Item 4.**Development Application: 13-15 Bayswater Road, Potts Point**

File No.: D/2018/1411

Summary

Figure 10: Proposed layout of existing roof terrace

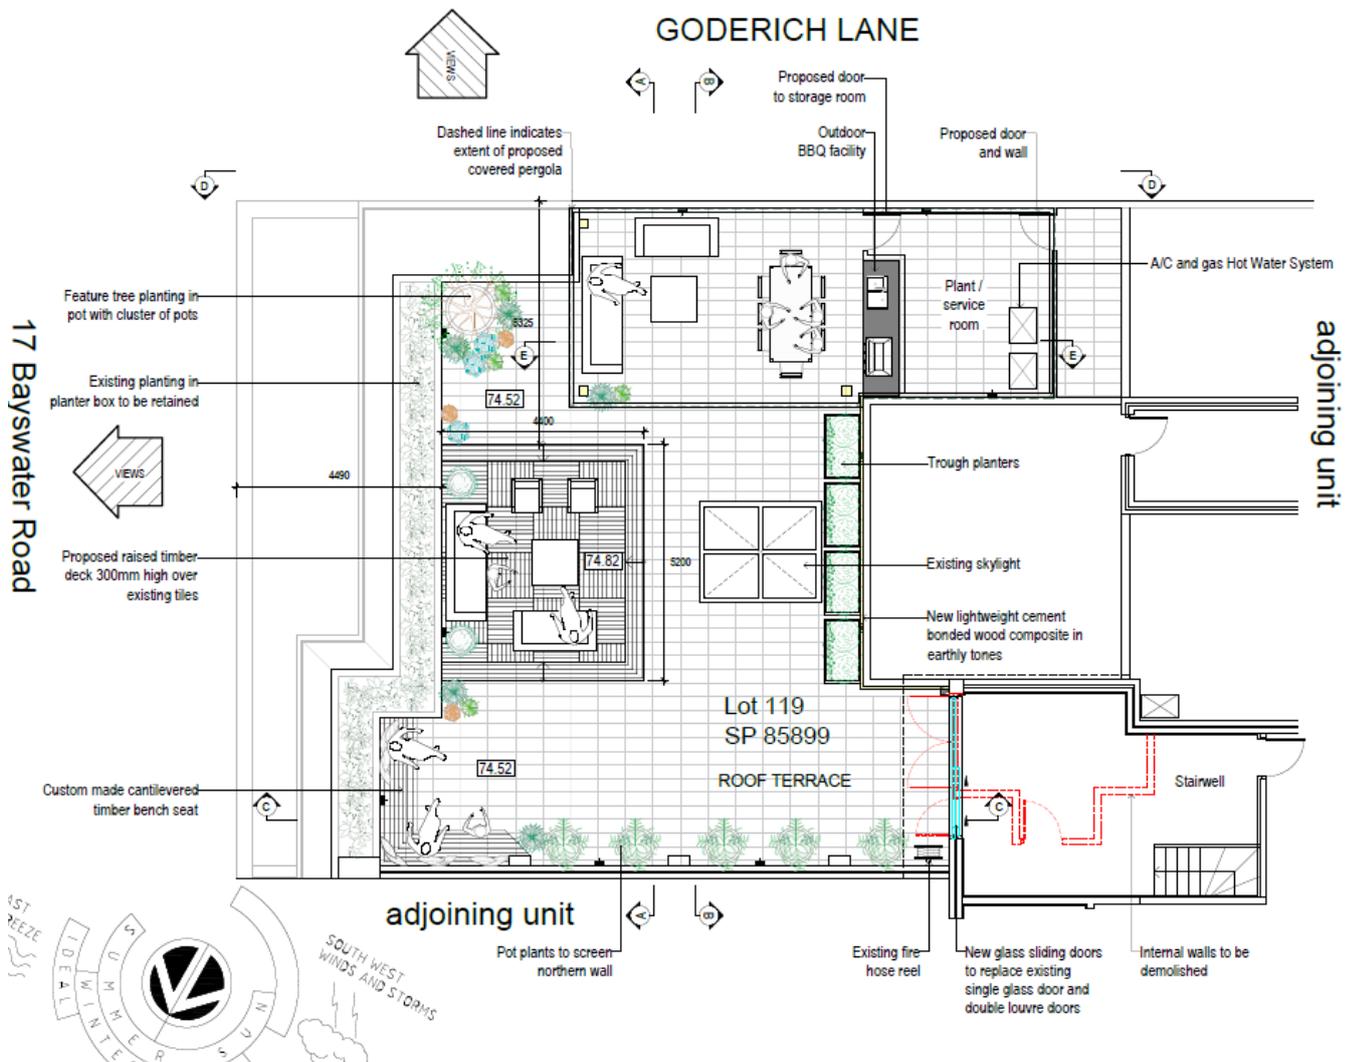
34. The conditions of other sections of Council have been included in the proposed conditions. Council's Heritage and Urban Design officers do not object to the proposal, subject to the plant room being deleted or reduced in size, which has the potential to be used as storage and would be additional Gross Floor Area (GFA). A condition is also recommended requiring specific materials and colours to be submitted.

- (e) The new storage room will add GFA and no details of FSR for the site have been provided.

Response - The proposed plant room is recommended to be reduced in size to ensure that it will house the plant only and not be used for storage, which would be additional GFA. A condition is also proposed stating that the plant room cannot be used for storage.

Figure 11: Section of terrace with pergola looking east

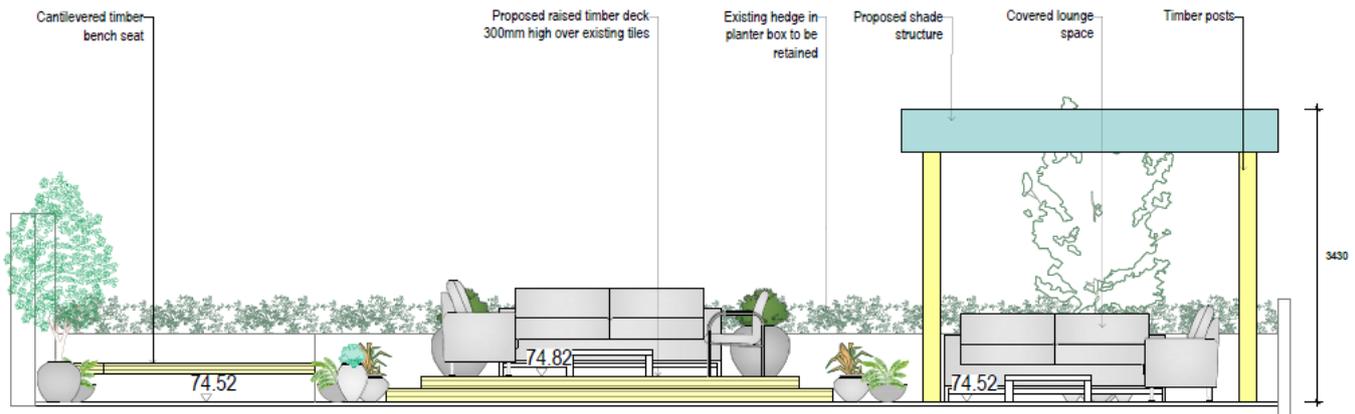
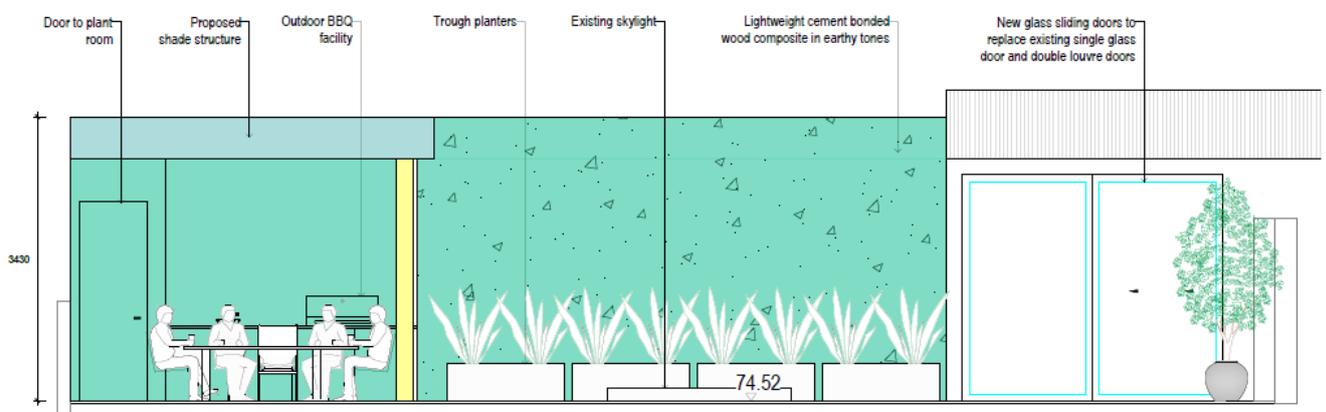
17. The site is permitted to have a maximum height of 27m under Clause 4.3 of Sydney LEP 2012. The proposed development seeks a maximum height of the building of 34.88m. This exceeds the maximum permitted height by 7.88m or 29.2%.
18. The additional height is a result of the proposed pergola and plant structure on the existing roof terrace; however, is below the highest point of the existing structures on the building.
19. In accordance with Clause 4.6 of Sydney LEP 2012, the applicant has submitted a written justification seeking exception to the Height development standard, which is discussed below.

20. The site is subject to a maximum height control of 27m. The proposed development has height of 34.88m, a 29.2% variation to the height control.

30. For the reasons provided above the requested variation to the height standard is supported as the applicant's written request has adequately addressed the matters required to be addressed by cl 4.6 of the Sydney LEP 2012 and the proposed development would be in the public interest because it is consistent with the objectives of Height development standard and the B2 Local Centre zone.
